ALAMEDA COUNTY COMMUNITY DEVELOPMENT AGENCY
PLANNING DEPARTMENT

STAFF REPORT

APPLICATION: PLN2021-00044

PROPOSAL: **MODIFICATIONS TO PREVIOUS APPROVAL FOR VESTING TENTATIVE TRACT MAP SUBDIVISION AND SITE DEVELOPMENT REVIEW**, to allow revision to a new mixed-use multi-family project with 138 (previously 163) rental housing units, 11,049 (previously 11,524) sq. ft. of indoor retail, 983 (previously 660) sq. ft. of outdoor retail seating area, no proposed realignment of Via Mercado.

Figure 1
Approved (2019) Village Green Project

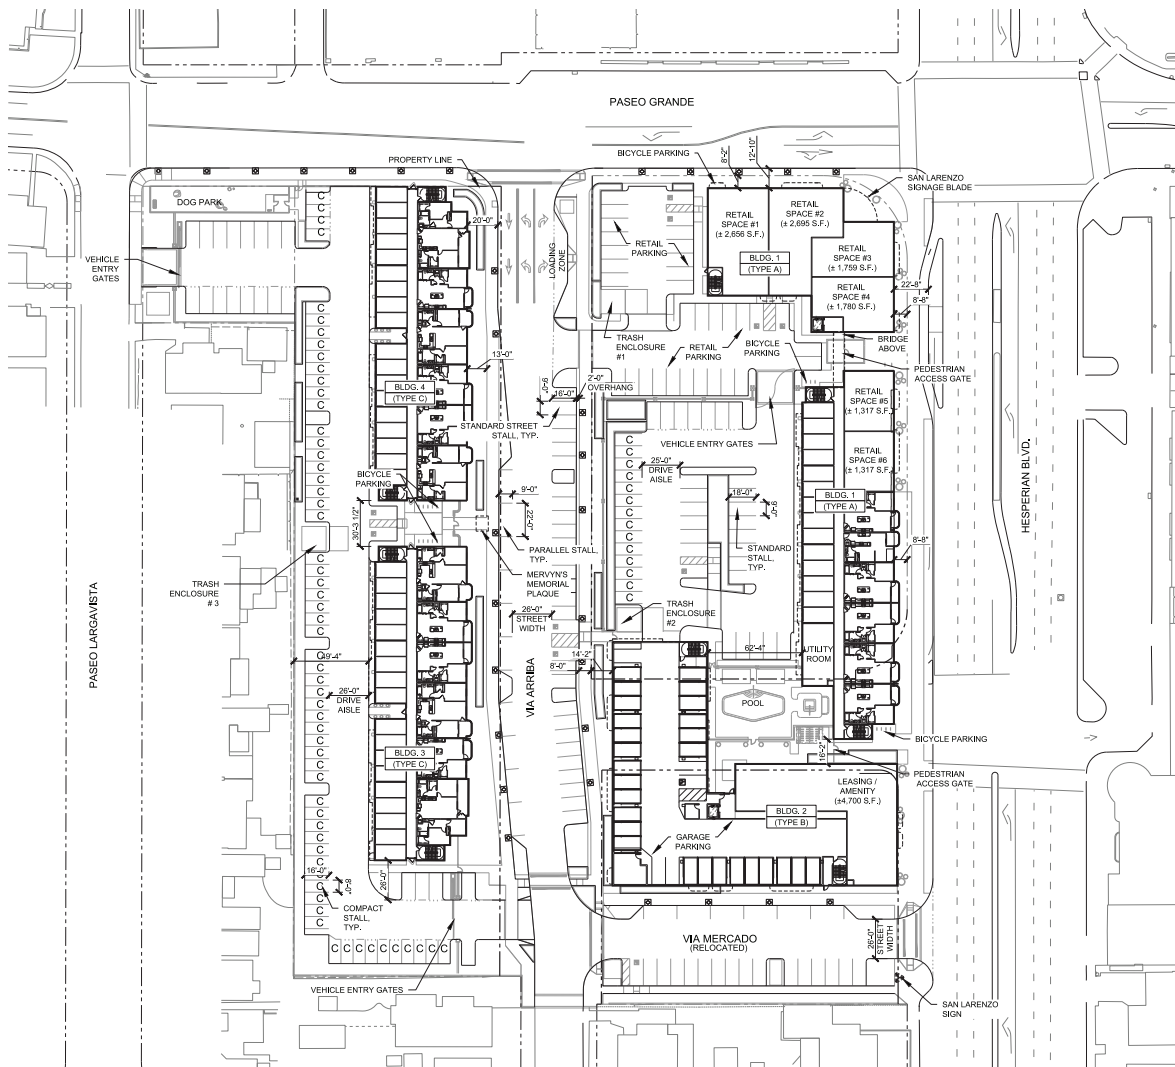
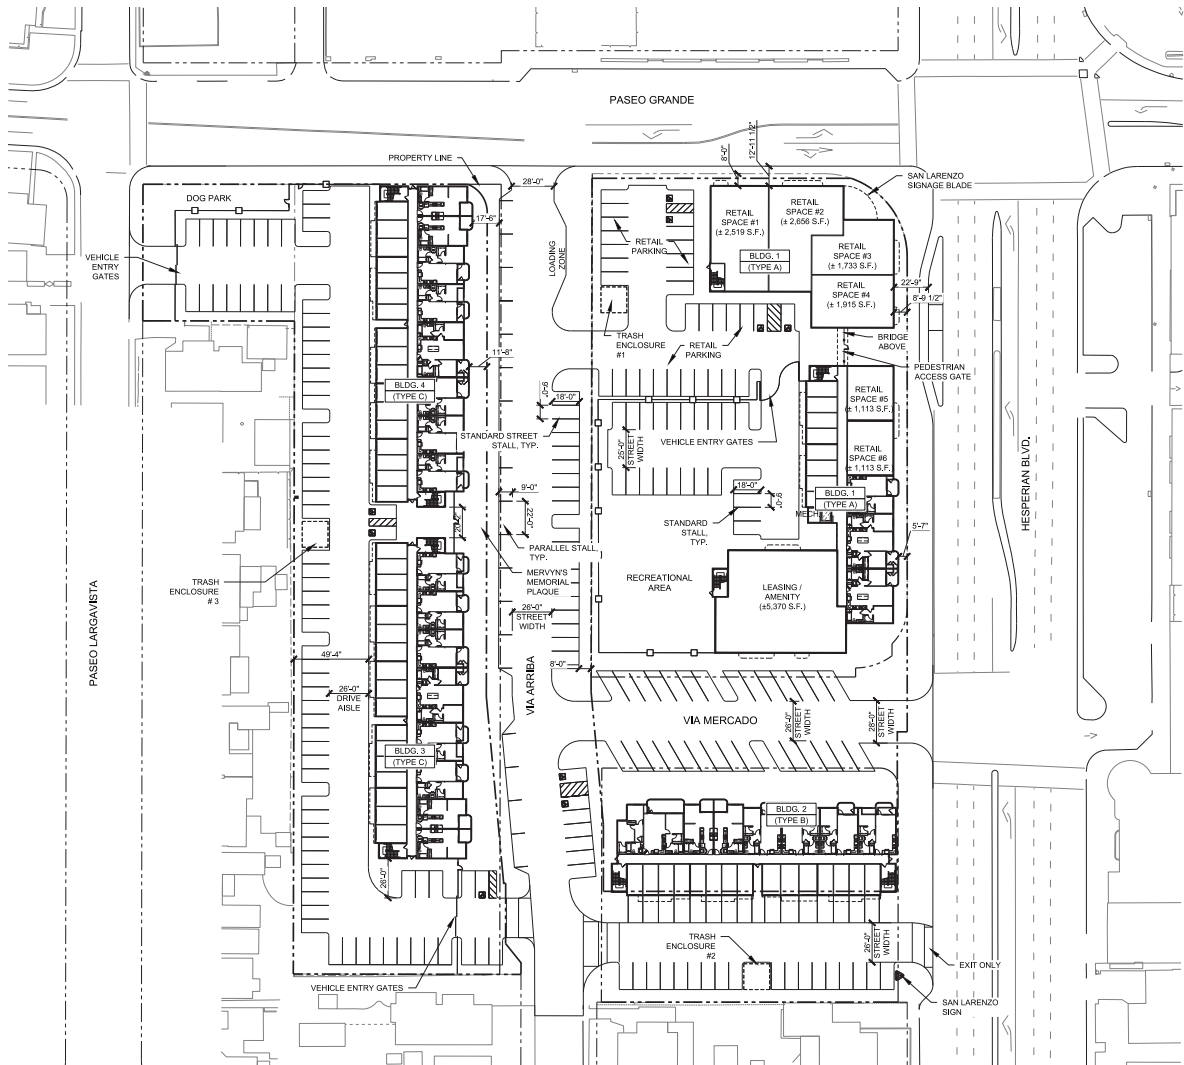
The originally approved Village Green project as upheld on appeal by the Board of Supervisors in July of 2019, is as shown on **Figure 1**. The currently proposed Project (as revised) is shown on **Figure 2**. The fundamental changes between the approved project and the current Project are as summarized below in **Table 1**.
